USAID RAPID START HOUSING PROJECT  
FOR GAZA AND THE WEST BANK

REVIEW OF ENGINEERING AND IMPLEMENTATION ISSUES

Prepared by  
CENTER FOR FINANCIAL ENGINEERING AND DEVELOPMENT

Draft Report

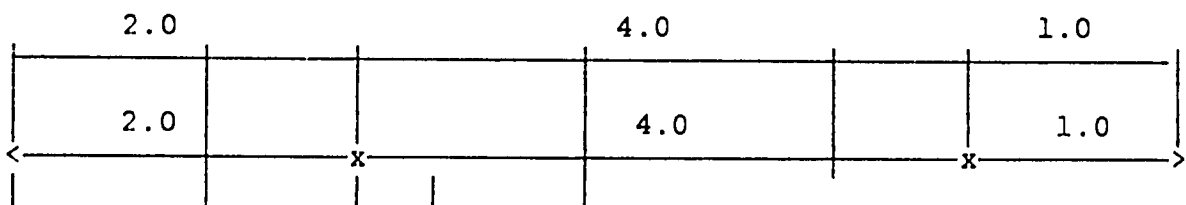
4. Dimensional lines do not appear to have limits (see the upper line below); please correct all dimensional lines to indicate the distances that correspond with the figures (see lower line below):
